CITY OF PEQUOT LAKES
BOARD OF ADJUSTMENT
NOTICE OF PUBLIC HEARING - VARIANCE REQUEST
MONDAY, SEPTEMBER 22nd, 2025
6:00 P.M.
AT
CITY HALL
4638 MAIN STREET

Hearing: Variance Application #25-04 to construct a deck addition to an existing residential dwelling proposed within the required lake setback of Sibley Lake & Southern property line side yard setback.

STAFF REPORT –Public Hearing | September 22nd, 2025

Application: Variance #V25-04 to construct a proposed deck addition to an existing legal non-conforming dwelling within the required setback to the OHW & Side Yard property line.

Excerpt from Certificate of Survey provided with the Application:

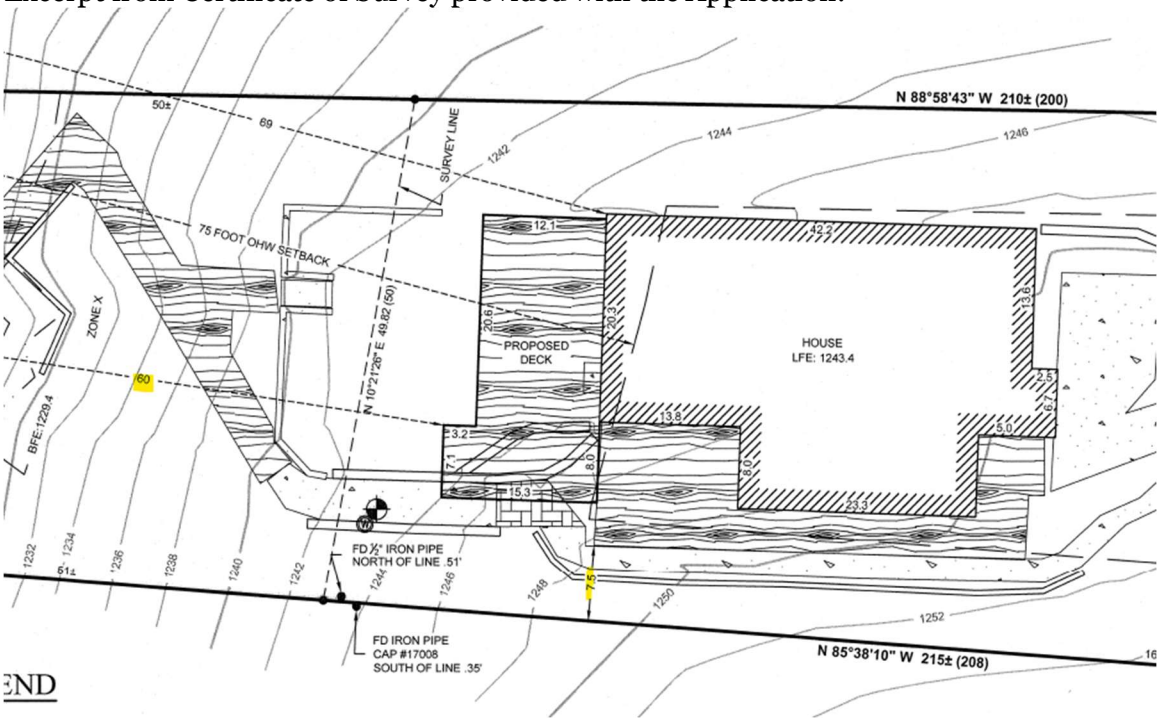
5. The proposed deck as shown on the Certificate of Survey is 60' from the Ordinary High Water mark where 75' is the minimum requirement.
6. The proposed deck as shown on the Certificate of Survey is 7.5' from the Southern property line (side yard) where 10' is the minimum requirement.

7. The impervious surface calculation as provided on the Certificate of Survey denotes "proposed conditions will not increase impervious coverage" and includes a total impervious surface percent for the subject property of 30.7%.

1. A stormwater management & erosion control plan shall be submitted to the City for review upon submission of a land use permit for construction on the property. The stormwater plan, at a minimum, shall contain information pertaining to temporary or permanent best management practices to direct runoff of stormwater away from adjacent water bodies and parcels, and provide details of the location & type of erosion control methods to be established prior to and throughout construction on the property.

2. Any impervious surface proposed or constructed that is not included on the provided Certificate of Survey shall require resubmission of a variance application to exceed the maximum impervious surface allowed as stipulated in the Shoreline Residential Zone lot, use, and density requirement found in Section 17-5.8.

3. The deck shall remain open and be constructed out of materials that allow for the passage of stormwater through the structure to unpaved and unimproved surfaces below the proposed footprint of the deck.

SHEET TITLE:
Mark Barry
651-399-0671
Deck Remodel/Addition

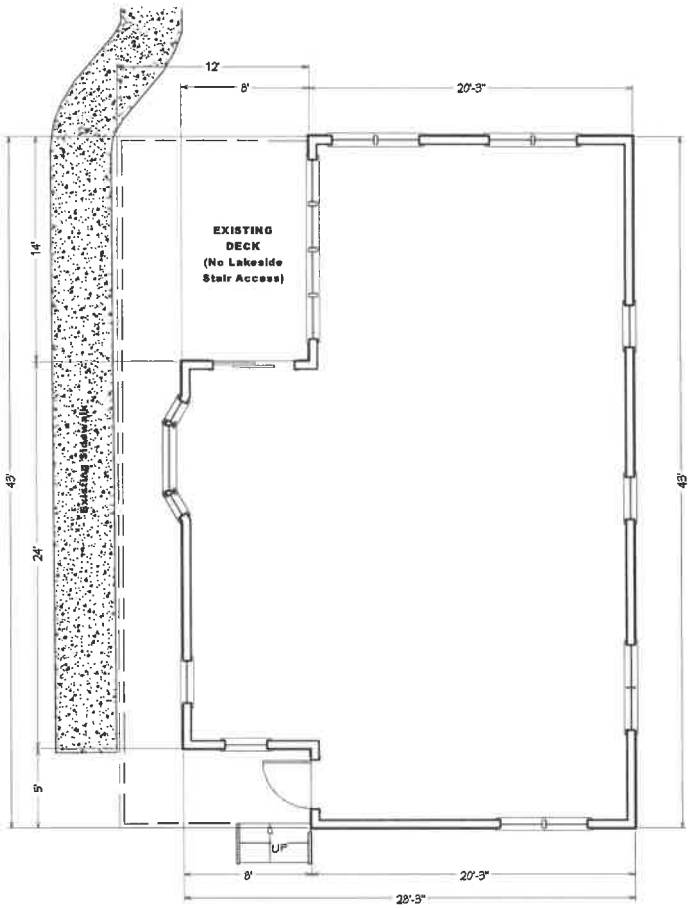
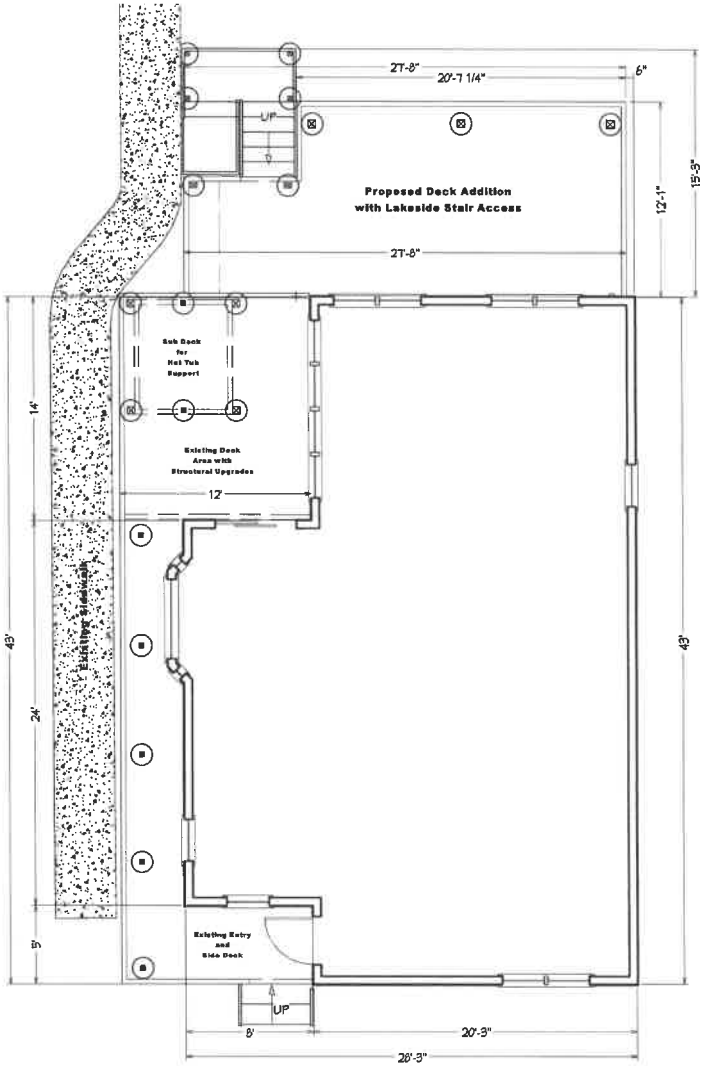
State nature of request in detail: (What are you proposing for the property?)
EXTEND DECKING TOWARD THE LAKE 12' TO ACCOMODATE A HOT TUB IN THE EXISTING DECK AREA. DECK EXTENSION WILL INCLUDE LAKE ACCESS STAIRS ~~NOT EXACTLY~~ DOWN TO CURRENT SIDEWALK. DRAWING SHOWS THE STAIRCASE EXTENDING ANOTHER 4' TOWARD THE LAKE.

Building: DECKING ACROSS THE FRONT OF THE HOUSE PER PLAN

CERTIFICATE OF SURVEY

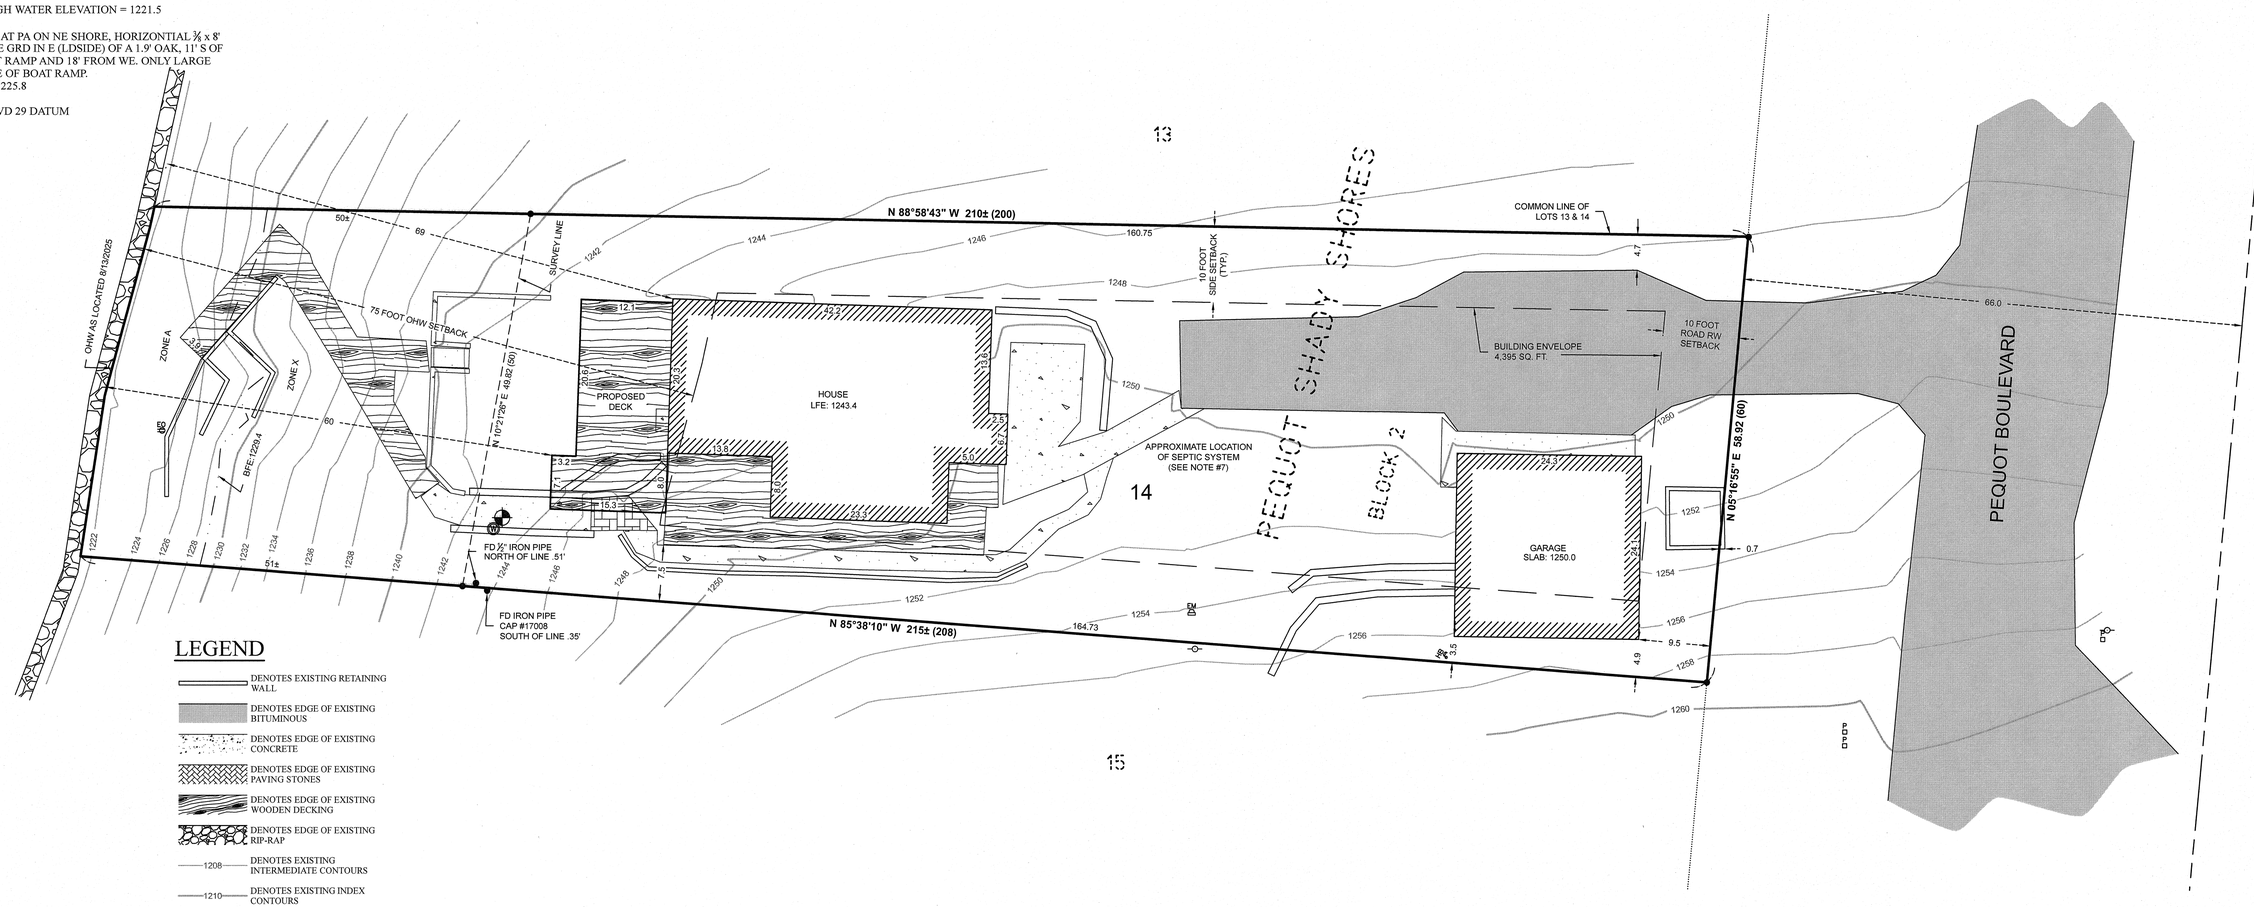
- "MN Rule 6120.3300 subp. 3J allows for the placement of new decks attached to existing legal non-conforming structures so long as the width of the deck does not exceed 15 percent of the existing shoreline setback from OHW and is not roofed or screened. If the applicant were to modify the request to propose a deck not to exceed 10 feet in width (15% of 69 feet from OHW to dwelling), no variance approval would be required and the project would still achieve the applicant's stated purpose of having a sitting area with a built-in hot tub. Given the above information, there appears to be no practical difficulty to overcome needing/requiring the variance. Therefore, the MN DNR recommends that the city consider the alternative of allowing a deck under the Shoreland Rule's 15% "deck" rule rather than approving a variance for which there appears to be not practical difficulty standard met."

- MN Rule 6120.3300 subp. 3J allows for the placement of new decks attached to existing legal non-conforming structures so long as the width of the deck does not exceed 15 percent of the existing shoreline setback from OHW and is not roofed or screened. If the applicant were to modify the request to propose a deck not to exceed 10 feet in width (15% of 69 feet from OHW to dwelling), no variance approval would be required and the project would still achieve the applicant's stated purpose of having a sitting area with a built-in hot tub. Given the above information, there appears to be no practical difficulty to overcome needing/requiring the variance. Therefore, the MN DNR recommends that the city consider the alternative of allowing a deck under the Shoreland Rule's 15% "deck" rule rather than approving a variance for which there appears to be not practical difficulty standard met.
